SERVICE BULLETIN

Bulletin No: JC-019-09

IDLER KIT 970395

Product Type: 26hp Kawasaki Liquid Cooled Full Size ZT

FIGURE 3

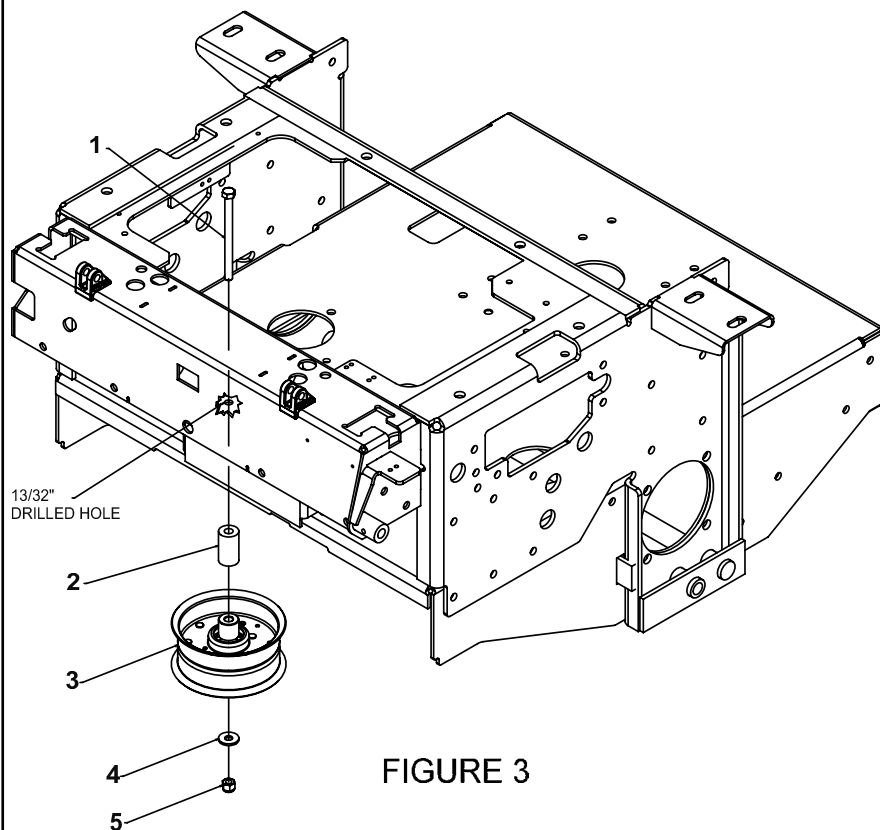
Issue: Sporadic reports of throwing/shredding PTO belt

Details: We issued a previous bulletin, JC-012-09 dated June 19, 2009, in reference to this issue. That bulletin is still valid, and while that bulletin corrected a cast majority of affected units, it did not rectify the situation in all units. The central issue is still harmonic PTO belt slap under heavy load. Typically, the belt rolls over on its back from slapping which results in the shredding of the belt cords which eventually ends with the belt thrown or breaking.

1. Cut out template 4164771 provided with kit.
2. Position the template inside the frame, aligning along the edges as shown in Figure 1 and Figure 2.
3. With the template in position, locate and center punch the drill location.
4. Remove the template and drill a 13/32" hole at the punch location.
5. Assemble the idler as shown in Figure 3.
6. Once assembled idler should appear as pictured in Figure 4.
